Iowa City Historic Preservation Commission

IOWA CITY HISTORIC PRESERVATION COMMISSION

Thursday, December 10, 2015

Historic Review for 429 Ronalds Street

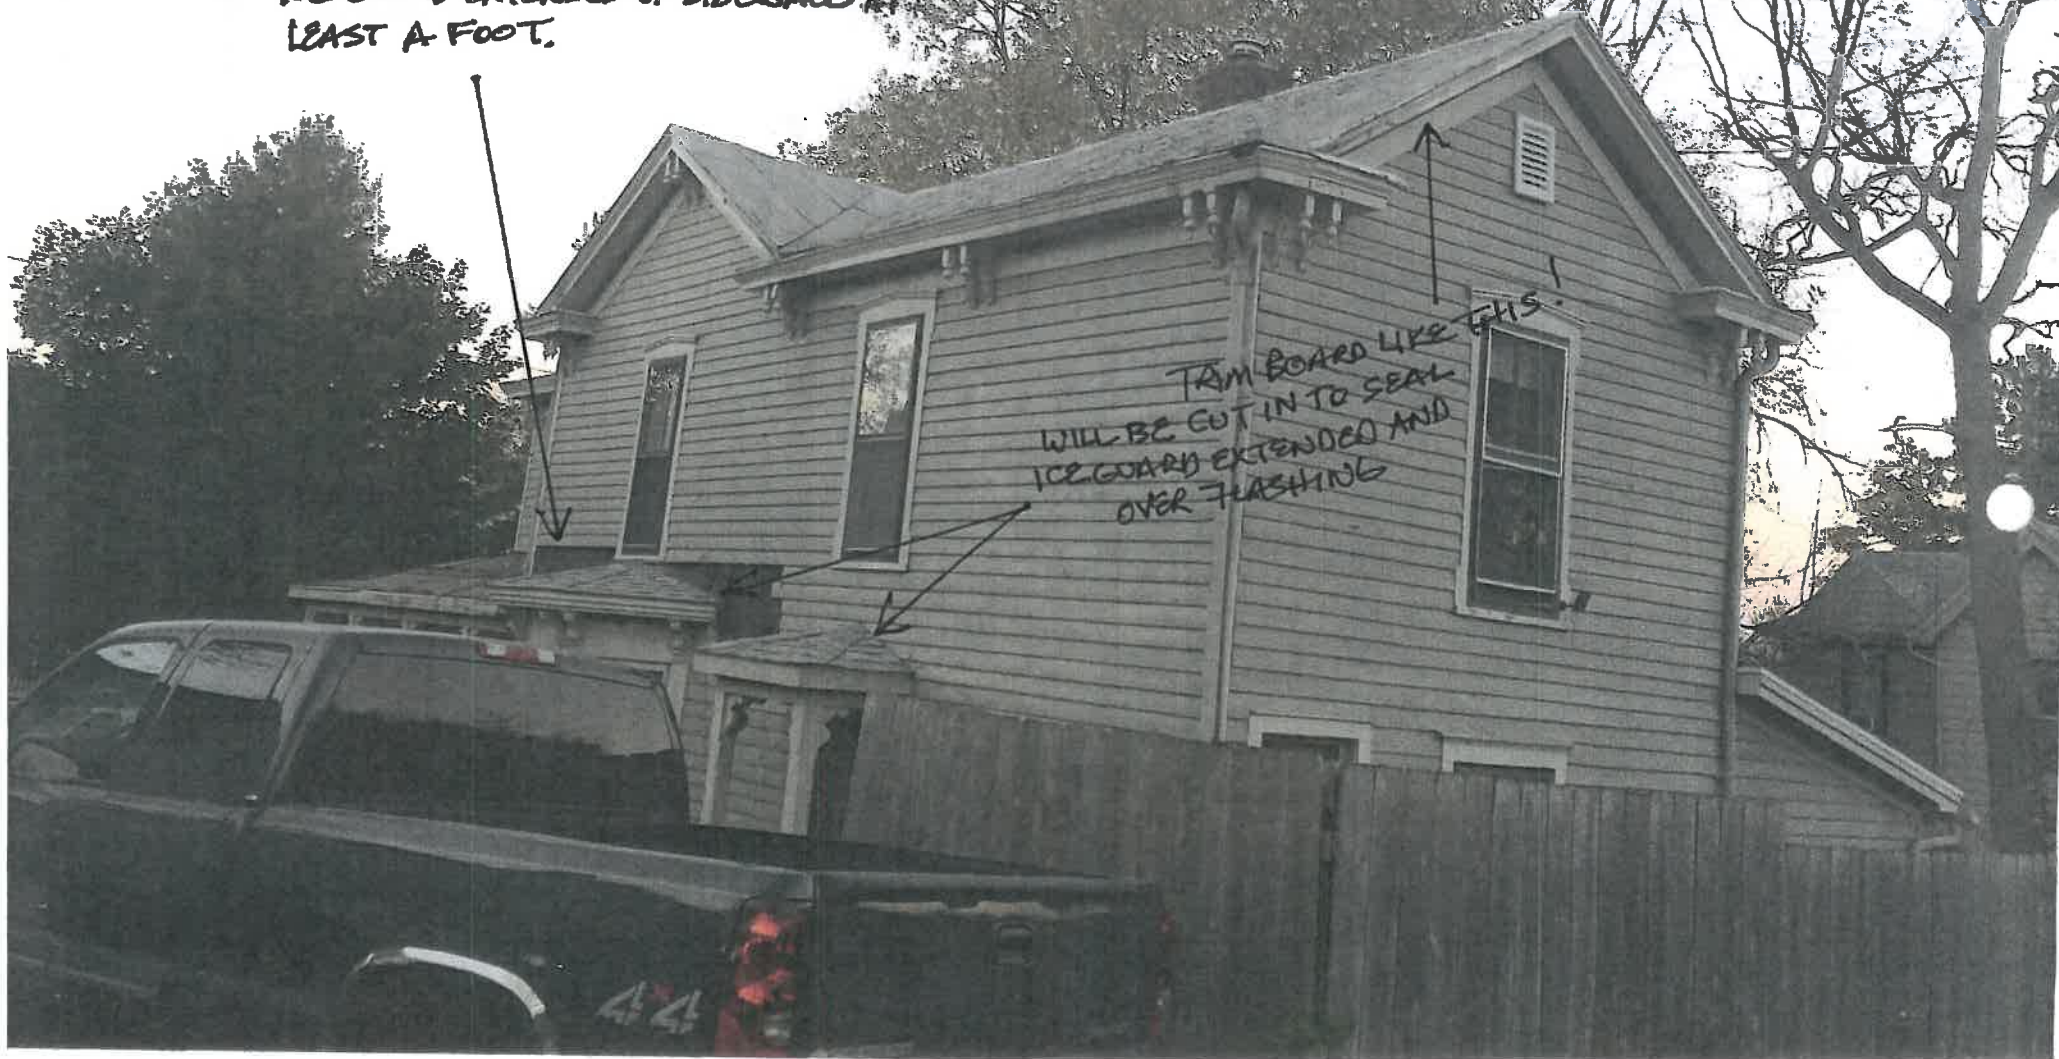
Staff finds the removal of the built-in gutters and crown molding and their replacement with smooth fascia and k-style gutters inappropriate and not in line with the Historic Preservation Guidelines. The cornice returns and built-in gutters are one of the most visually evident hallmarks of the Greek Revival style. At the time of the site survey, the house could have been considered individually eligible, or a key property, if the shingled siding was removed. Now that the house has lap siding and the front porch has been rebuilt, the house could be reevaluated. If, however, the crown molding and built-in gutters were removed, the house would lose one of the most evident pieces of its historic character.

Remove CROWN MOLDING TO "SQUARE" FACE
FOR PROPER INSTALLATION OF GUTTERS OVER
MEMBRANE BEHIND METAL FLASHING.

- Crown molding, built-in gutter, and fascia removal is not approved.

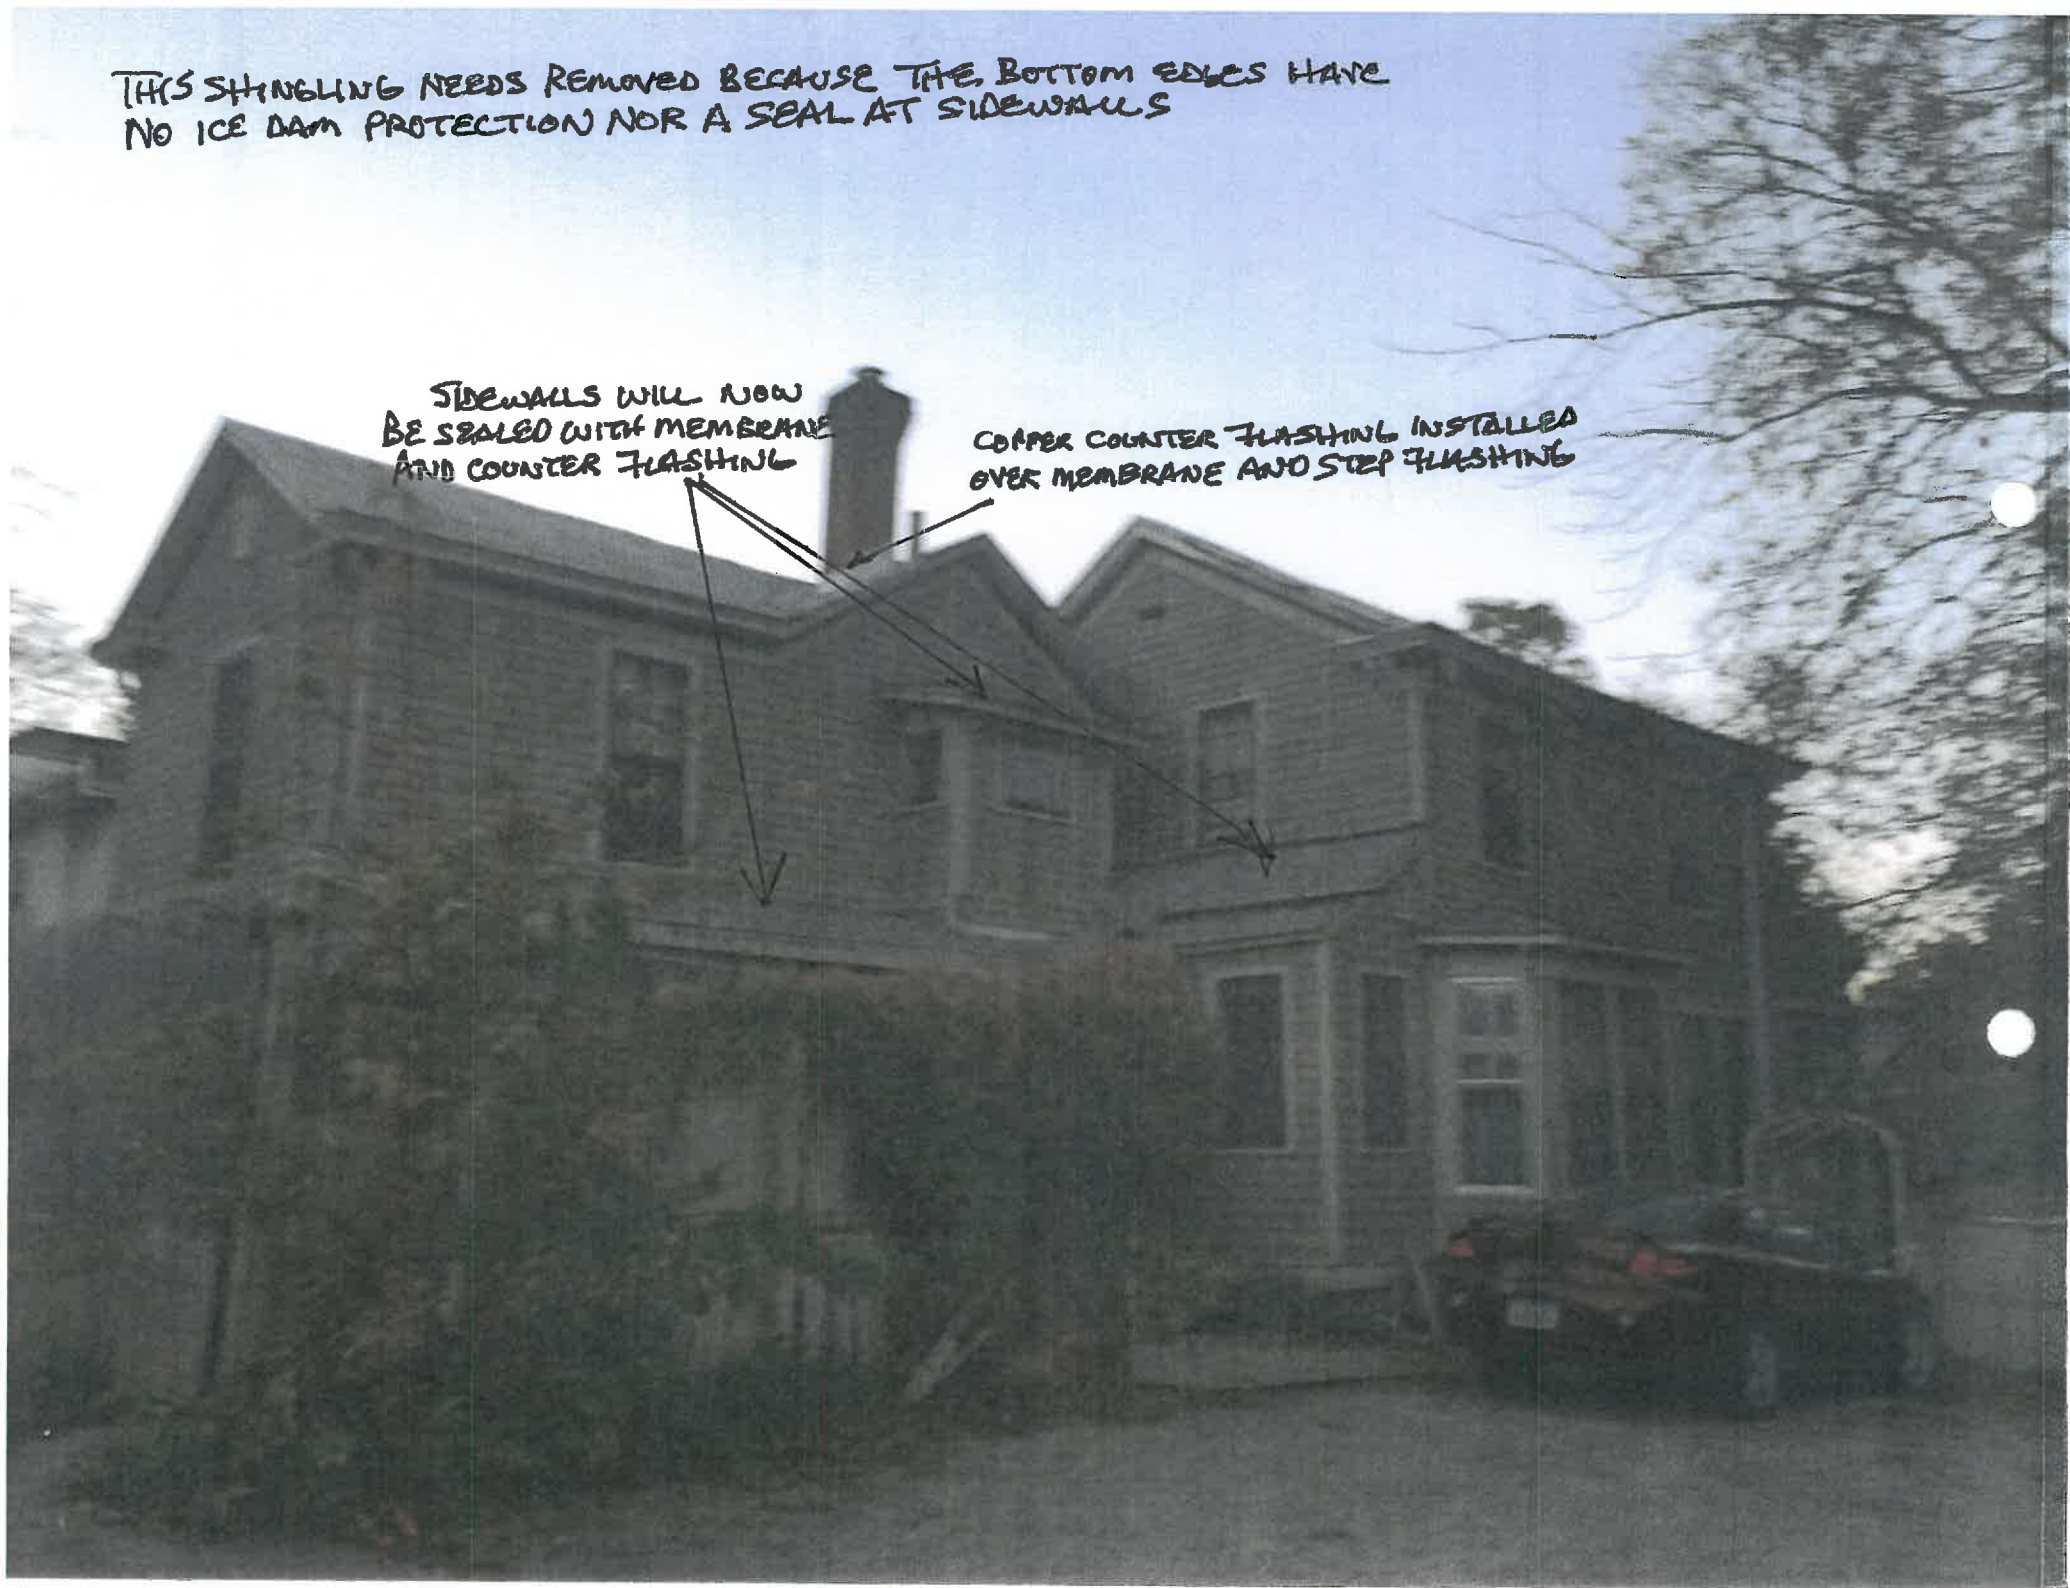
COPPER COUNTER FLASHING INSTALLED
OVER MEMBRANE AND STEP FLASHING

REMOVE CROWN MOULDING AT ALL BOTTOM EDGES
TO "SQUARE THE FACIA" FOR ICE GUARD TO BE
EXTENDED DOWN FACIA. NEW "K" STYLE GUTTER
TO BE INSTALLED ICE DAM PROOF. YOU WANT
TO GET WATER AWAY FROM FOUNDATION.
